SERVICE BULLETIN No 10-18

SUBJECT: NEW OIL SEAL FOR IGNITION DISTRIBUTOR
VEHICLES: TESTAROSSA, 328 GTB/S, 3.2 MONDIAL,
3.2 MONDIAL CABRIOLET, & 412

Fig. 1

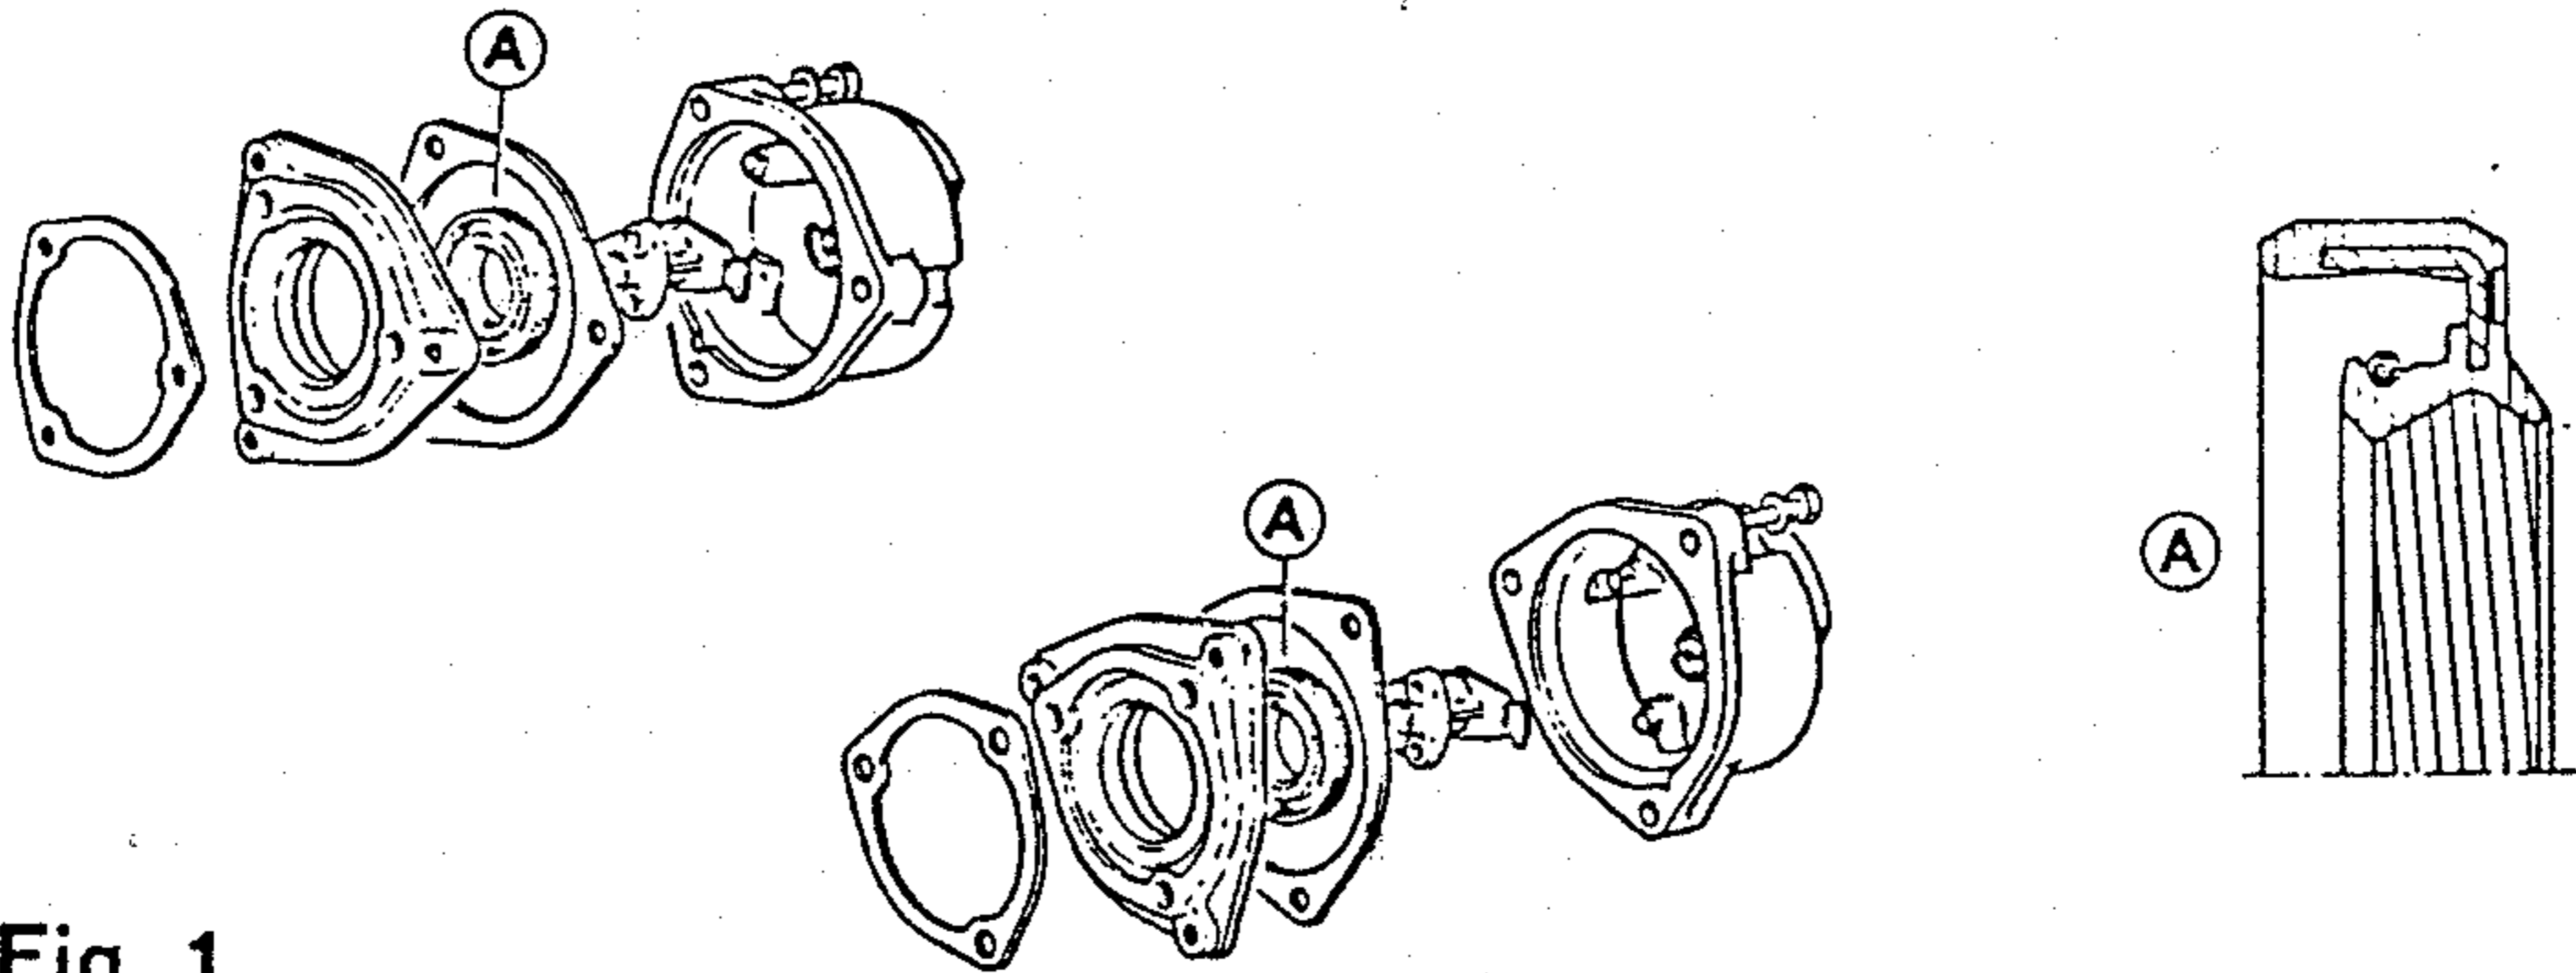
A new oil seal, with double lip, for ignition distributor (ref. A, Fig. 1) has been studied and introduced into production.

The new seal is available in 2 versions, each of them being suitable for one specific direction of camshaft rotation, and precisely:

P.N. 132452 (RED COLOR) for Testarossa

P.N. 132453 (BLACK COLOR) for 8 cylinder engines and 412

Fig. 2

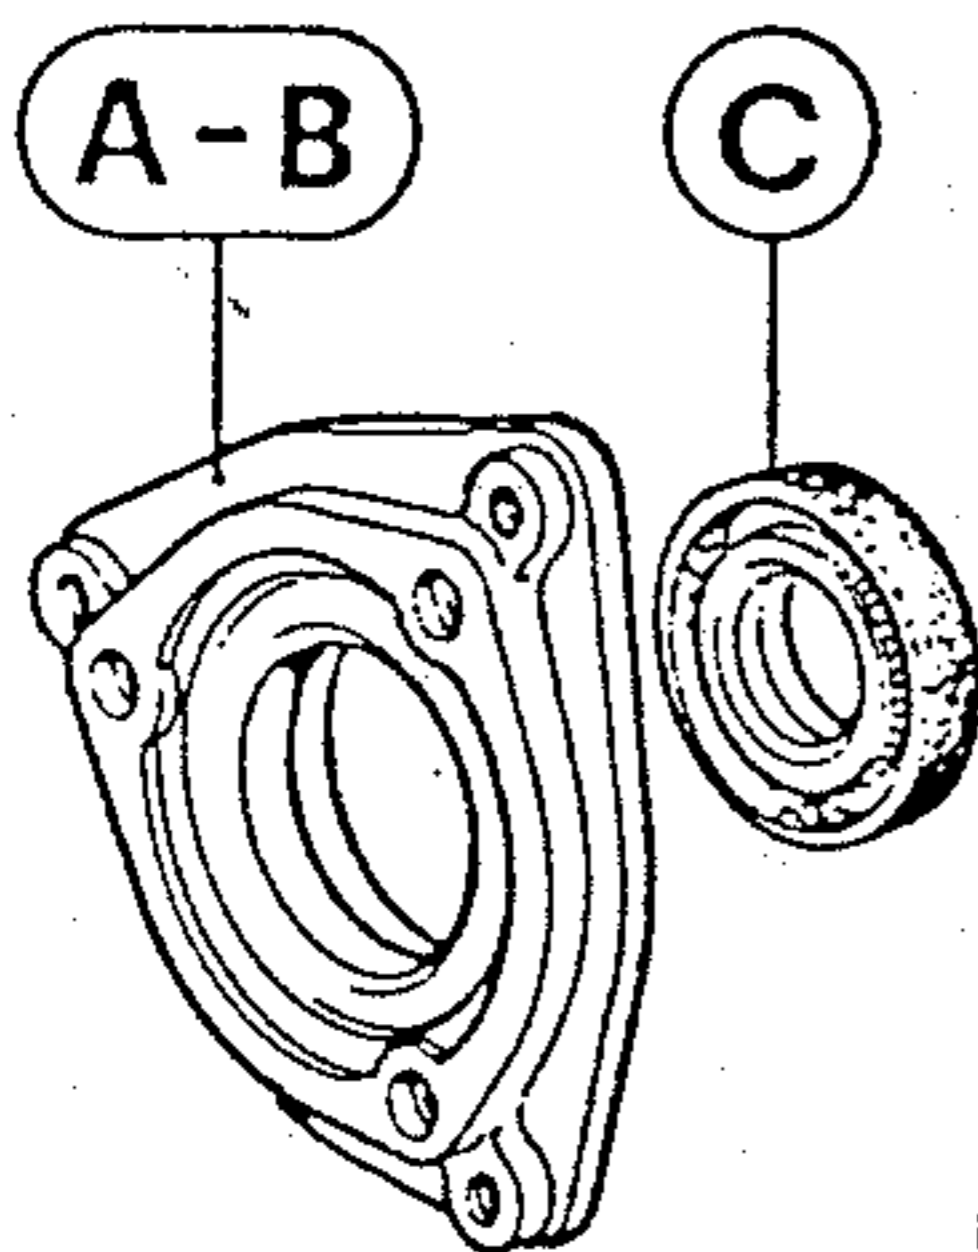
NOTE: The parts shown by Fig. 2 have been introduced into production.

(A) : P.N. 133346; Mounting flange
for ignition distributor 1-6

(B) : P.N. 133347; Mounting flange
for ignition distributor 7-12

(C) : P.N. 132452; Oil seal

Fig. 3

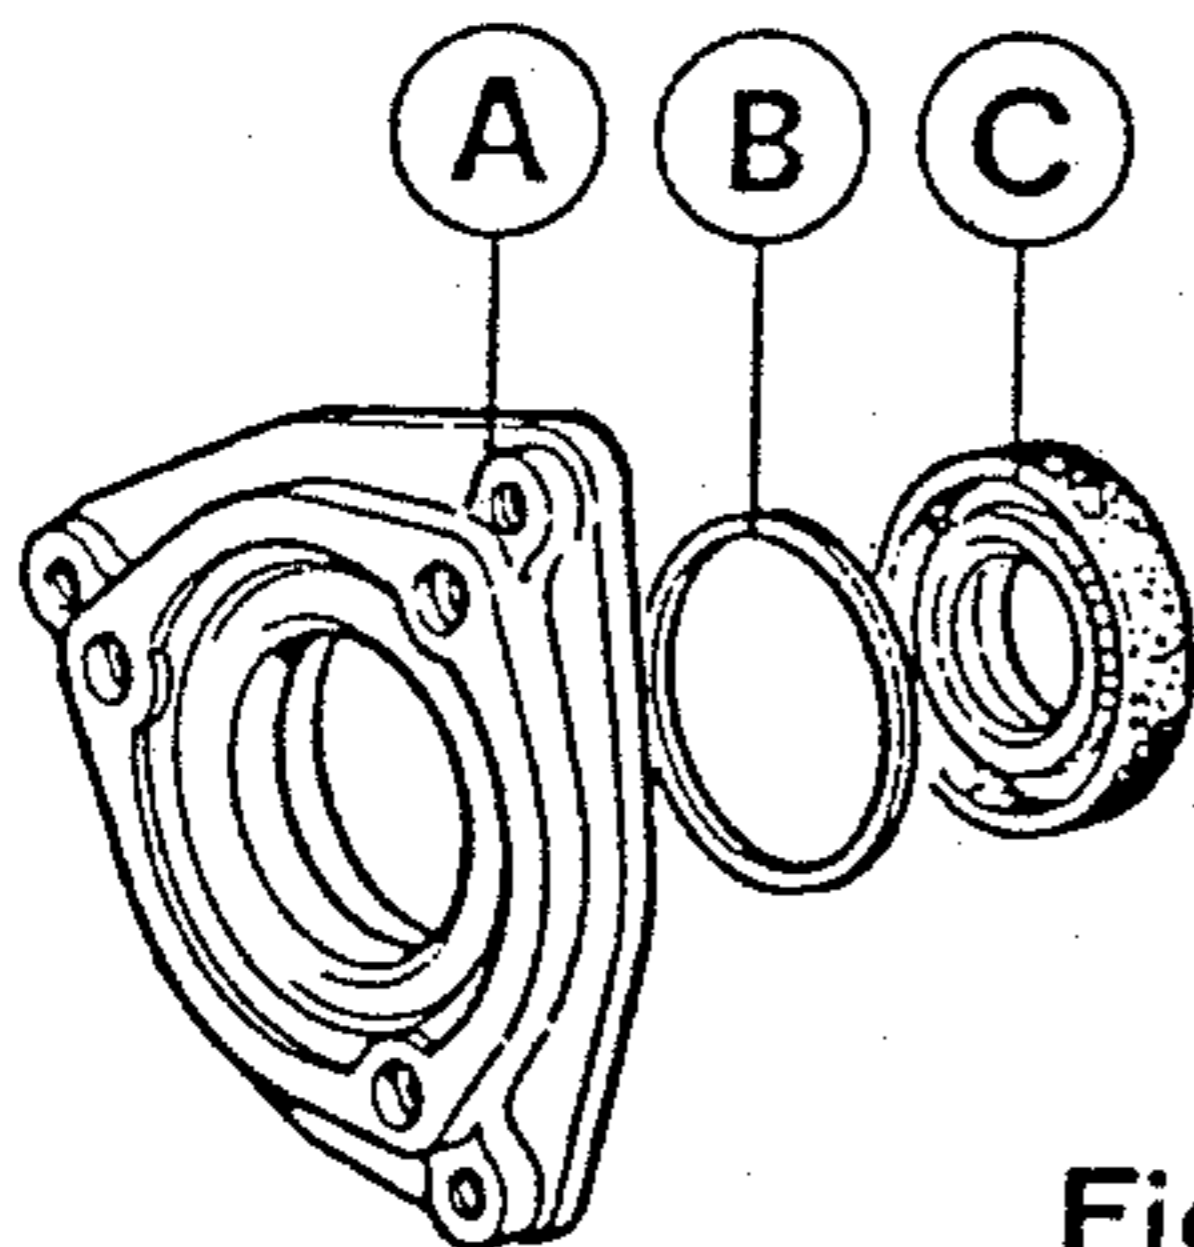
In case of replacement on a previous vehicle, employ the new oil seal p.n. 132452, which can be installed on the previous flange with the addition of the 1.25 mm spacer (as shown by Figure 3), in order to achieve a correct positioning.

(A) : P.N. 126115; Previous mounting flange for ignition distributor (bank 1-6 ÷ 7-12)

(B) : P.N. 133066; Spacer 1.25 mm

(C) : P.N. 132452; Oil seal

Fig. 4

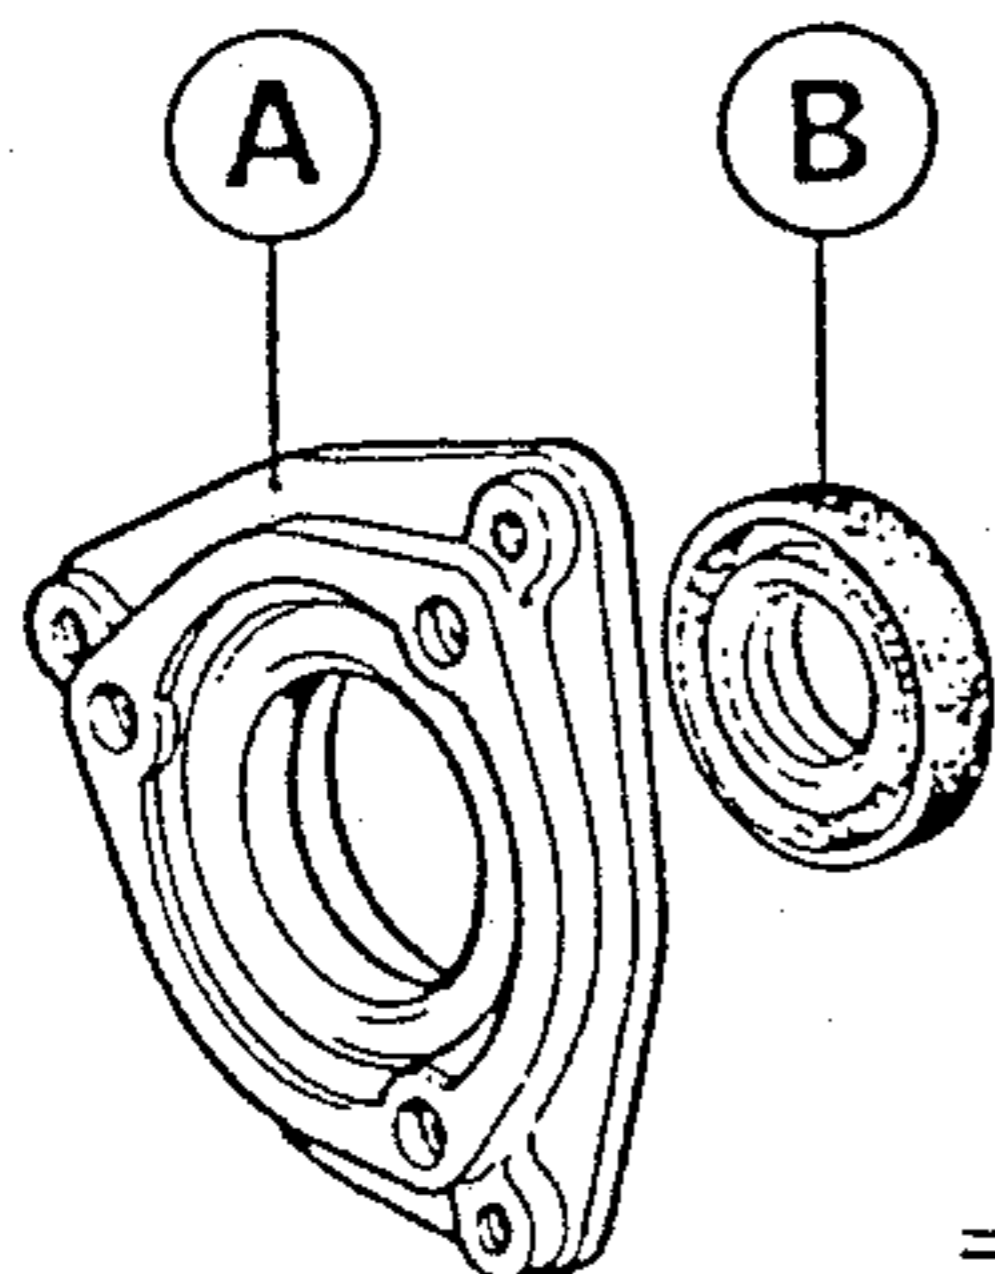
NOTE: The parts shown by Figure 4 have been introduced into production.

(A) : P.N. 133100; Mounting flange for ignition distributor (bank 1-4 ÷ 5-8)

(B) : P.N. 132453; Oil seal

Also in this case, for replacement of the seal originally installed, employ only the new seal p.n. 132453. For this purpose, you shall also install the new mounting flange for ignition distributor (p.n. 133100), as shown by Figure 4 (also the early type flange P.N. 126115 can be utilized with the 1.25mm spacer, P.N. 133066).

Fig. 5

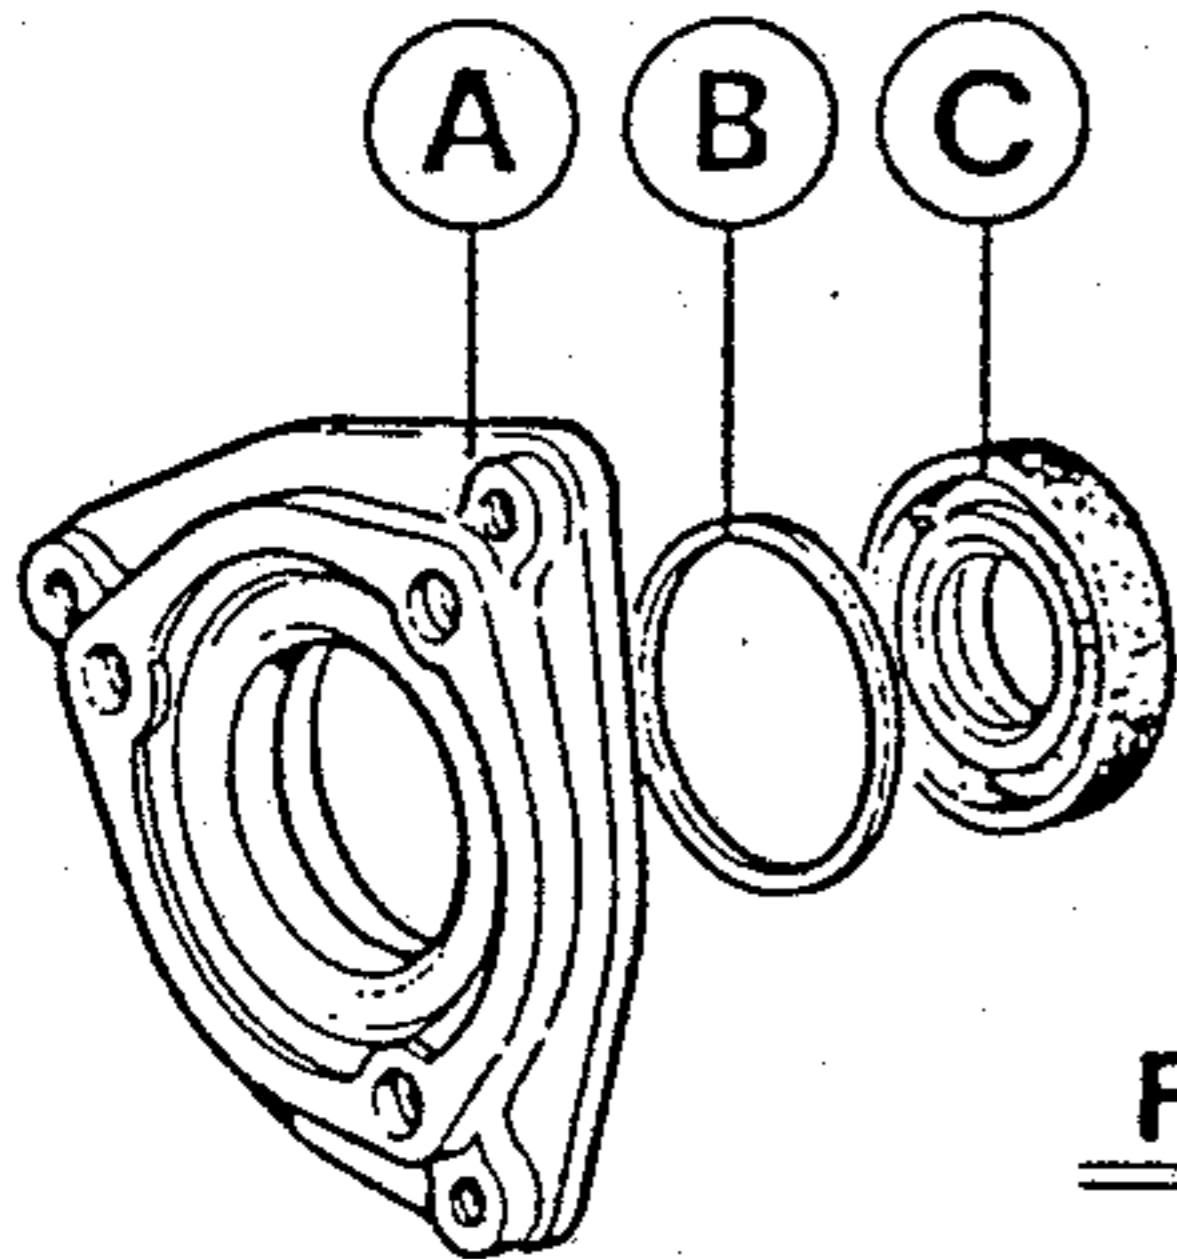
In case of replacement on a previous vehicle, employ the new oil seal p.n. 132453; which can be installed on the previous flange with addition of the 1.25 mm spacer (as shown by Figure 5), in order to achieve a correct positioning.

- (A) : P.N. 126115; Previous mounting flange for ignition distributor (bank 1-4 ÷ 5-8)
- (B) : P.N. 133066; Spacer 1.25mm
- (C) : P.N. 132453; Oil seal

Fig.7

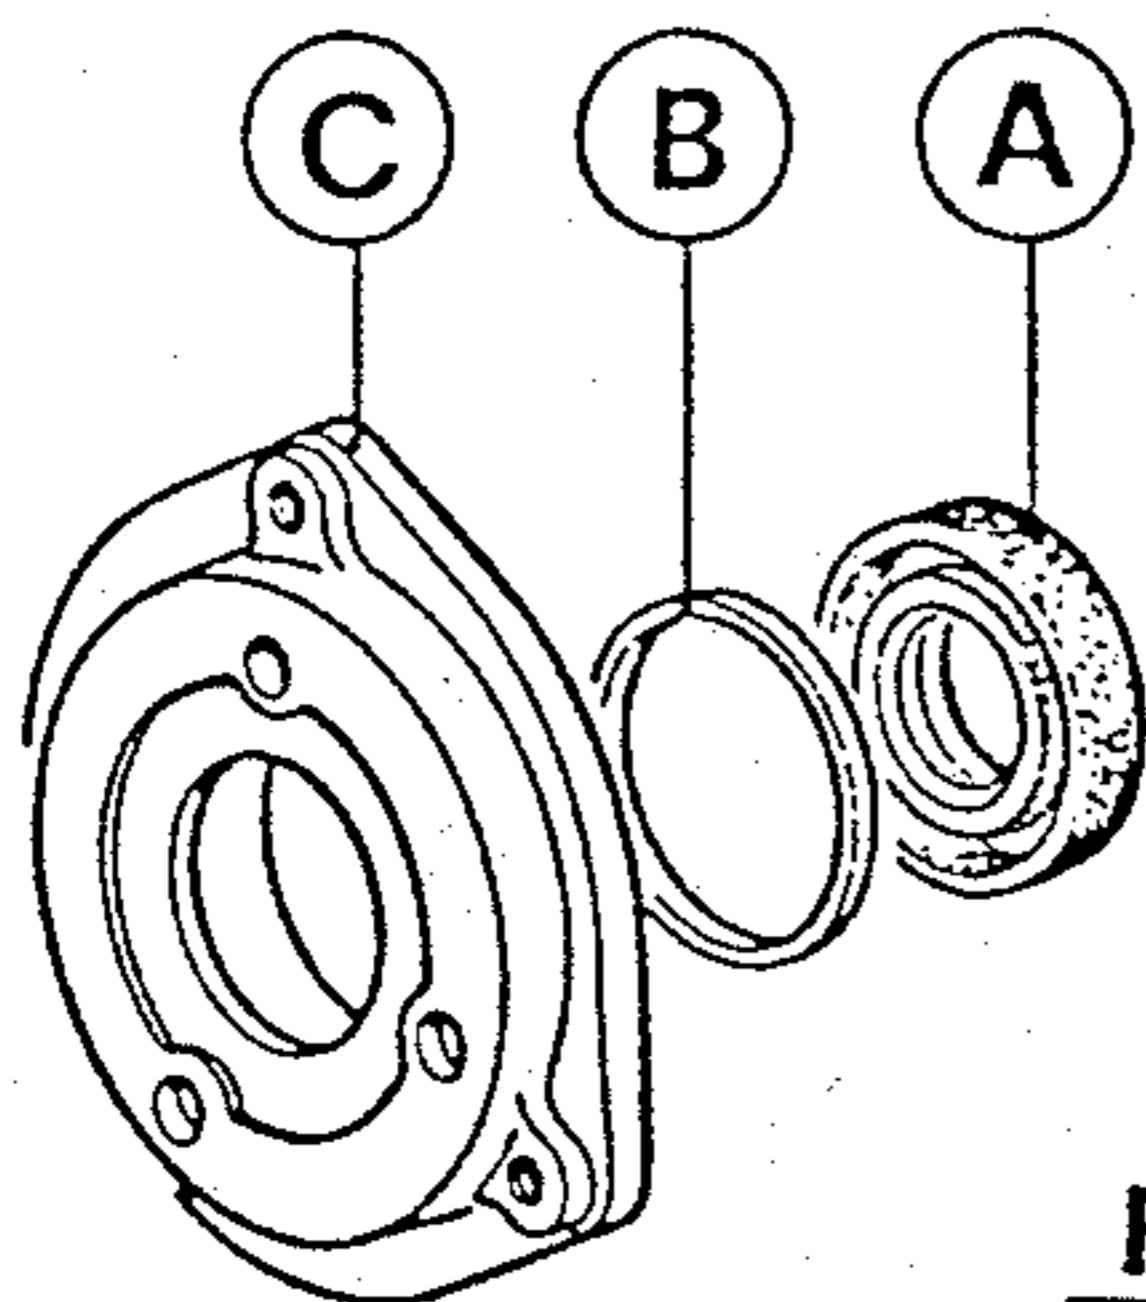
the parts shown by Figure 7 have been introduced into production.

In case of replacement on a previous vehicle, employ only the new seal p.n. 132453, which can be installed on the previous engines with the addition of the 2.25mm spacer (as shown by figure 7), in order to achieve a correct positioning.

- (A) : P.N. 132453; Oil seal
- (B) : P.N. 133070; Spacer 2.25mm
- (C) : Right and left mounting flange for ignition distributor, unchanged compared with previous engines
